To: Development Review Board
From: Michael Giguere, City Planner
Date: April 17th, 2025
Subject: 34 Park Street – final site plan application to add three dwelling units to an existing three-story mixed-use building with two dwelling units and commercial space in the Village Center district by Park Street Ventures, LLC, owner.
File: SP# 1.2025.1

Re: 34 Park Street Site Plan Application

SITE PLAN

MCEWING-MIXED USE

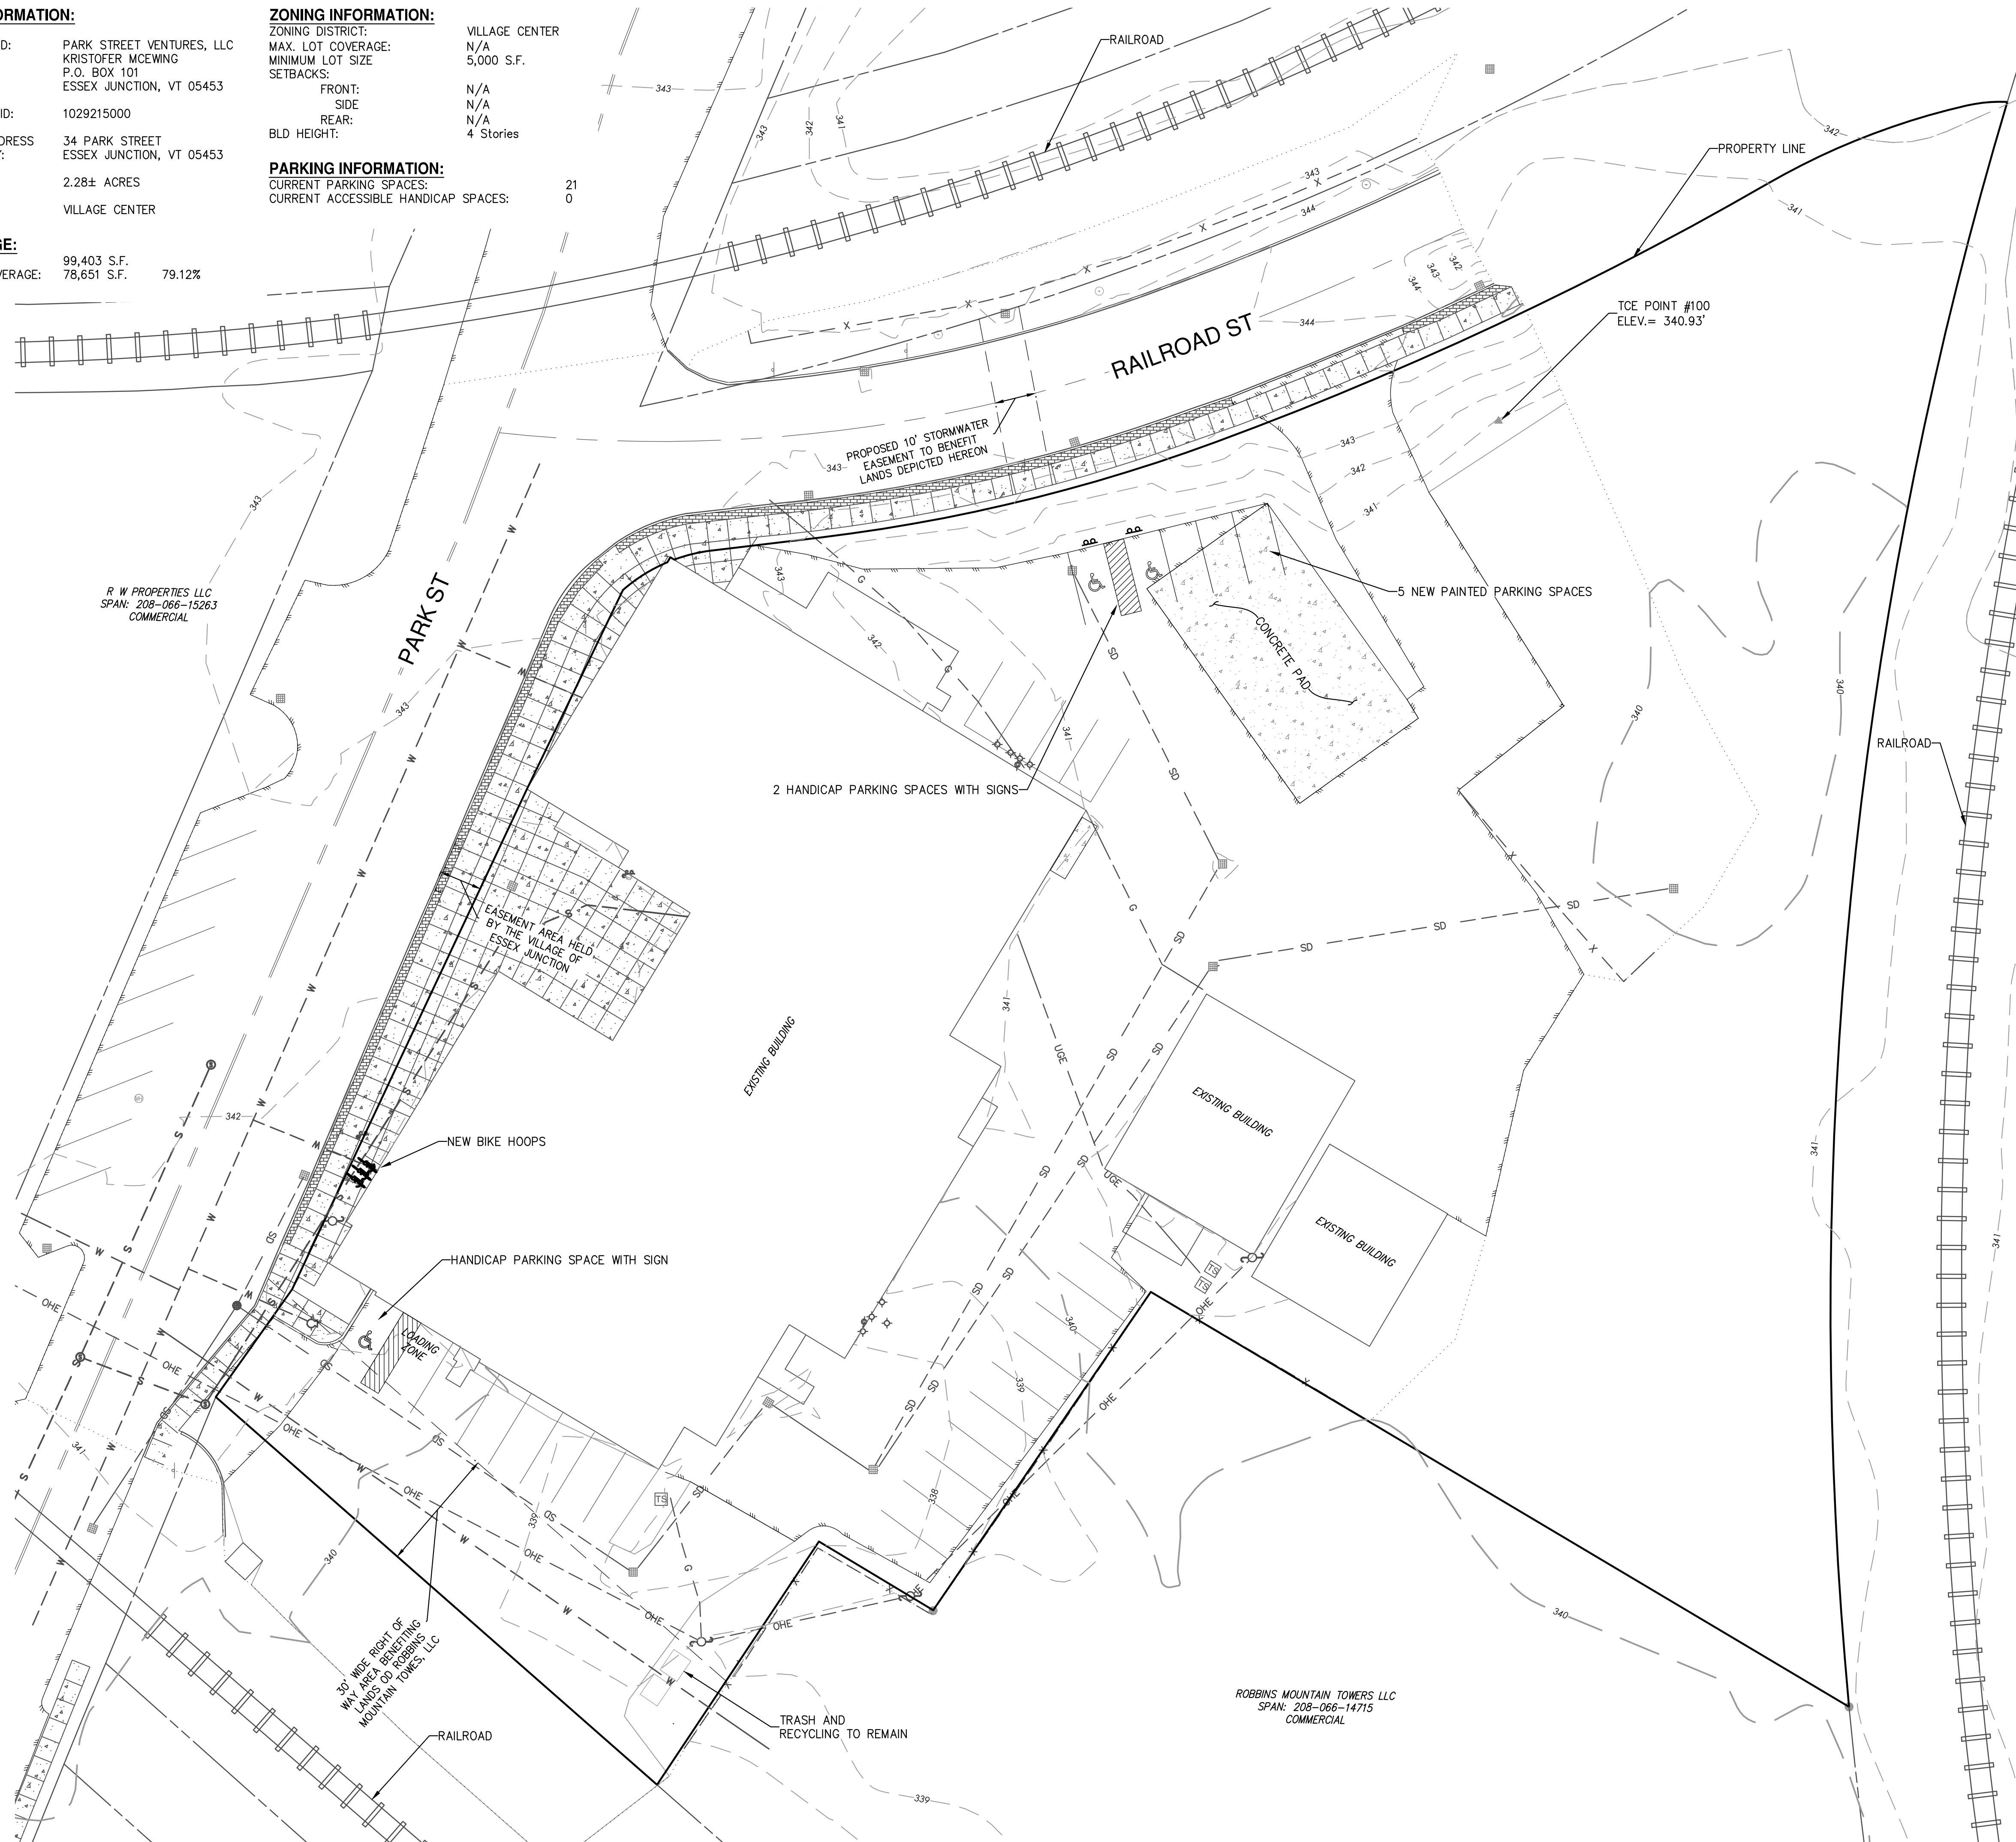
A minimum of eight (8) short-term bicycle parking spaces are required for this development, which can be served by four (4) hoop-style racks anchored to a hard surface. The applicant has proposed three (3) hoop style bike racks on their submitted site plans just to the north of the proposed pedestrian entrance for the new dwelling units. Staff have added amending site plans to meet the LDC’S minimum bike parking requirements as a condition of approval.

The applicant has included the location of the property's dumpster on their submitted site plan. Staff have added screening this from view or relocating it such that it is not visible from the public right-of-way as a condition of approval to meet the requirements of Section 706.J.

- Section 706.J of the Land Development Code requires the screening of any dumpster by non-transparent materials to a height of six feet if it is visible from the public right-of-way. Site plans should be amended to include this or relocate the dumpster such that it is not visible from Park Street.

LIGHTING PLAN

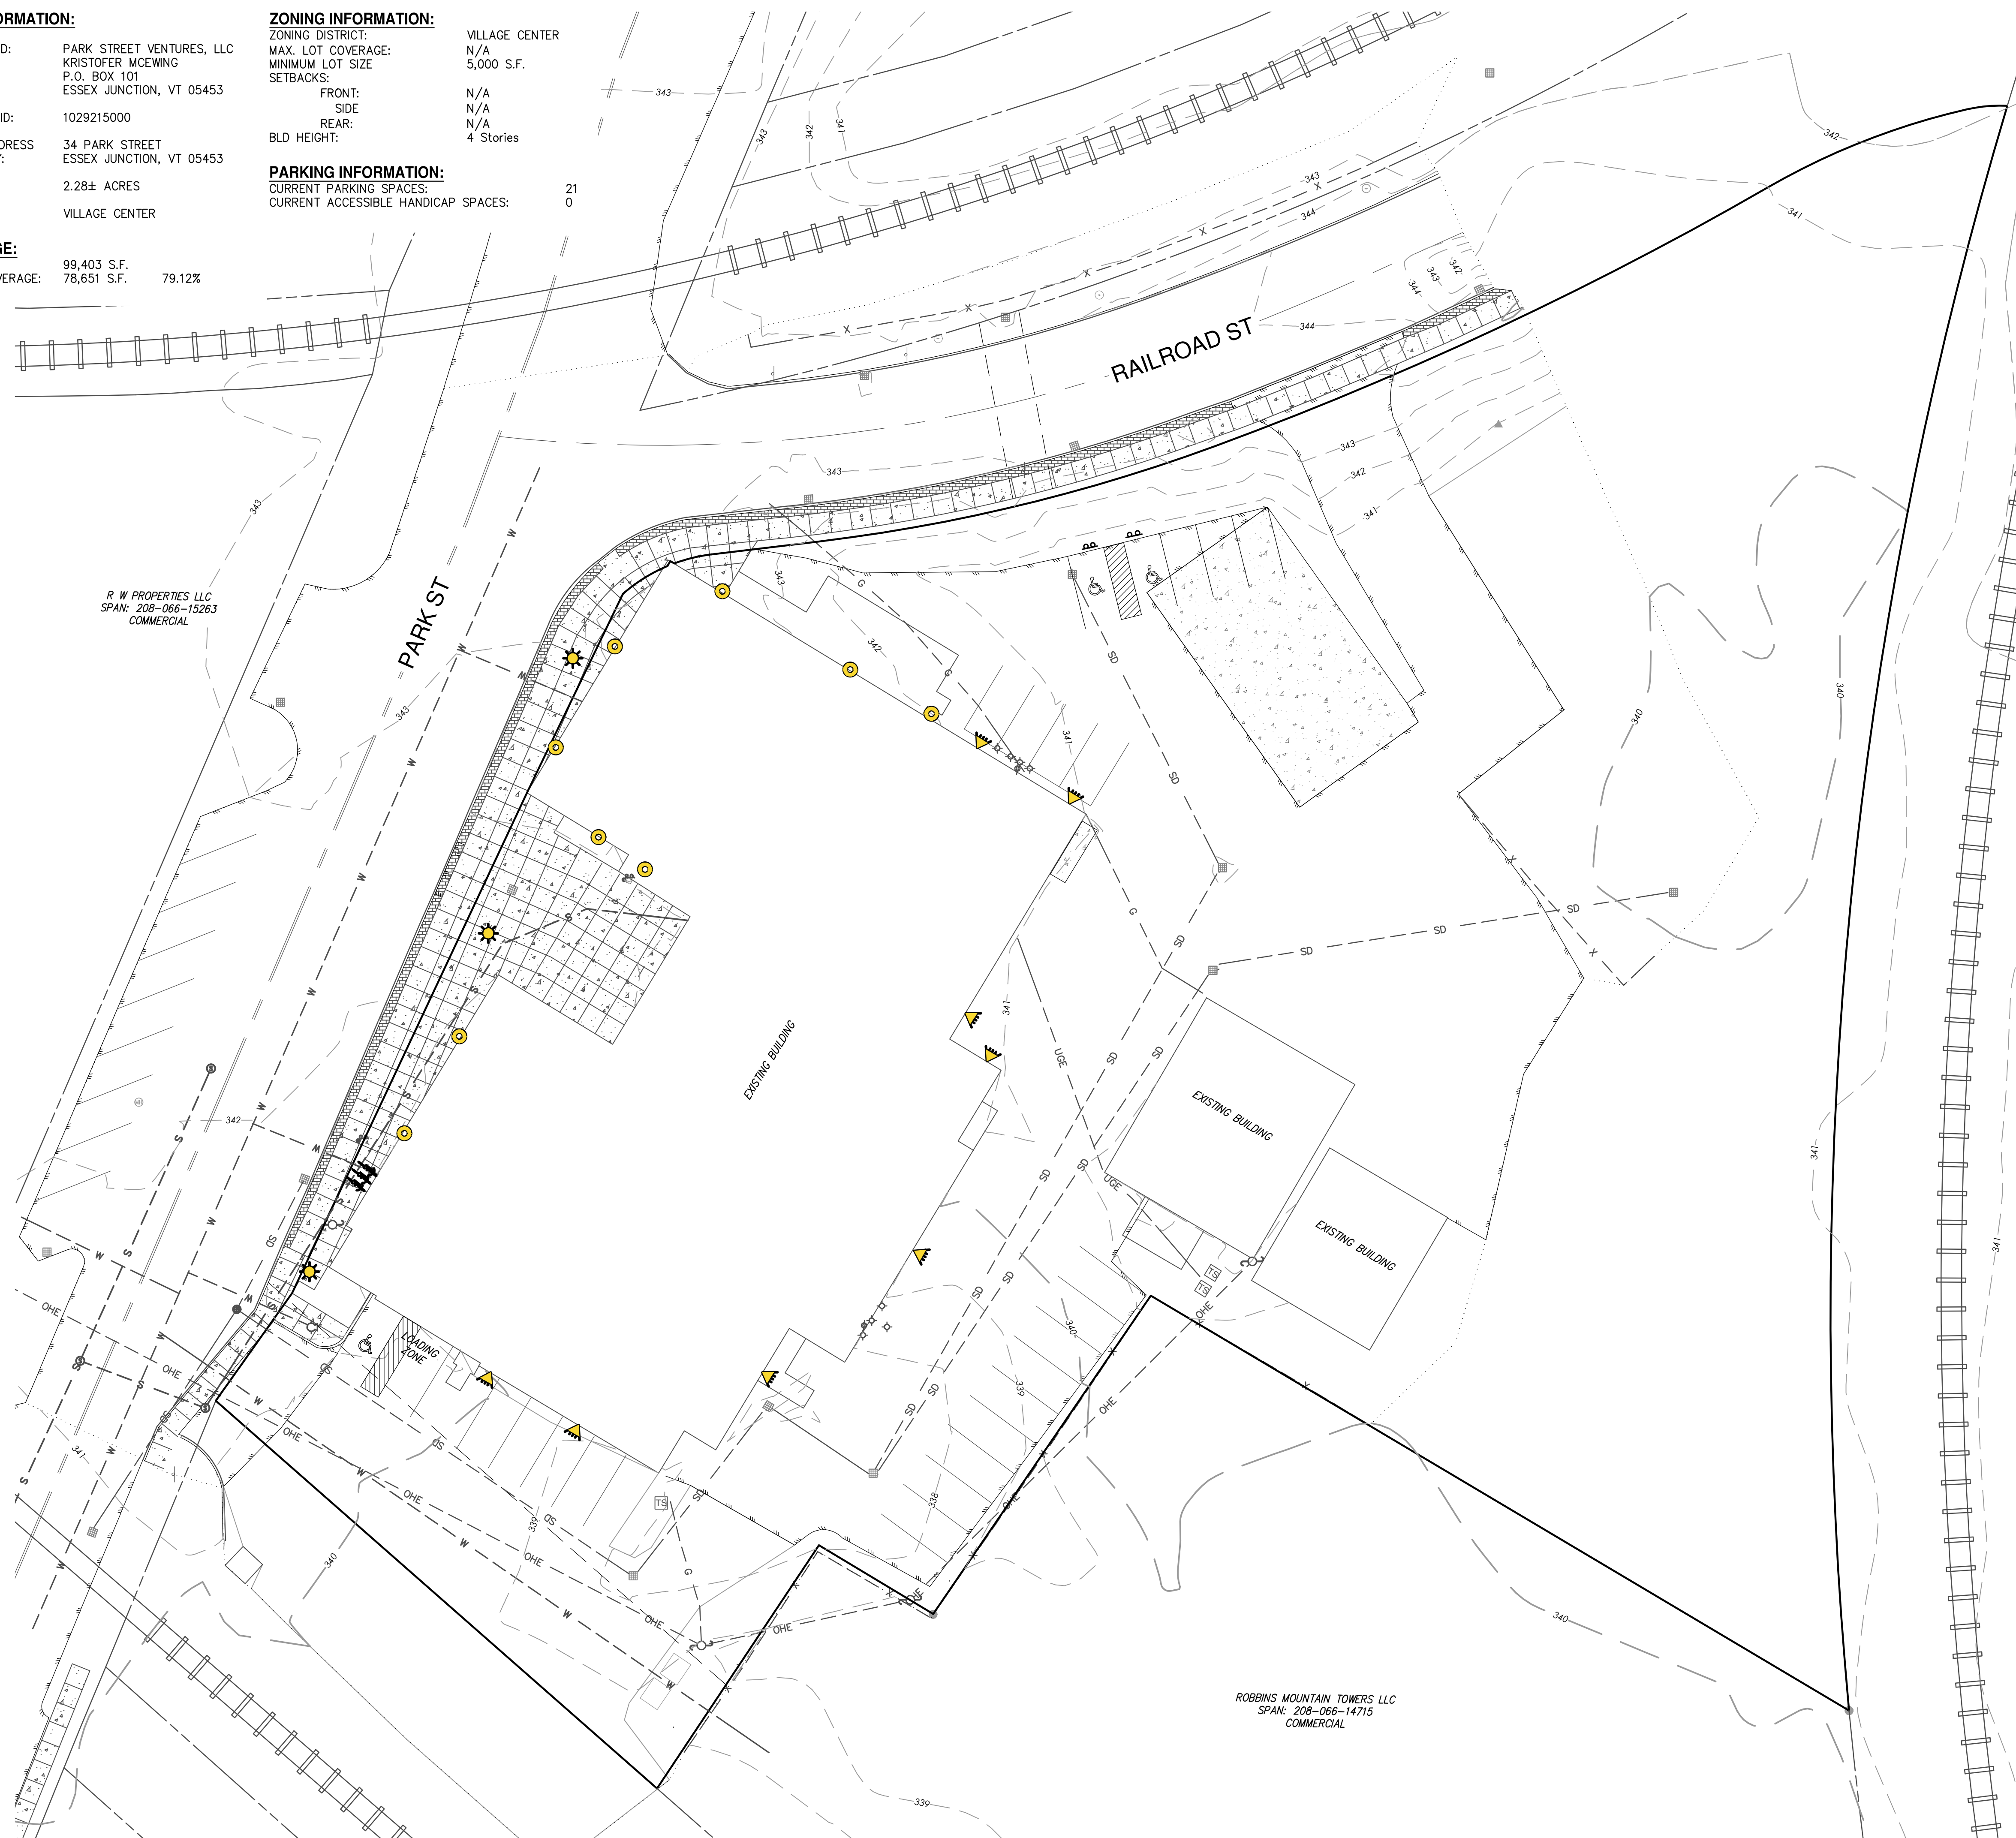
The applicant has submitted a lighting plan that shows the location of existing light fixtures and proposes no changes to these existing conditions. Upon review of these plans, staff have noted that there are eight (8) light fixtures on the building that are not dark sky compliant. Staff have added replacing these fixtures with dark sky compliant lighting as a condition of approval.

- Staff have noticed eight light fixtures on the included lighting plan that appear to be non-compliant as highlighted here:

The submitted lighting plan should be amended to bring the property into compliance. Lighting standards can be found in Section 704 of the Land Development Code for guidance.
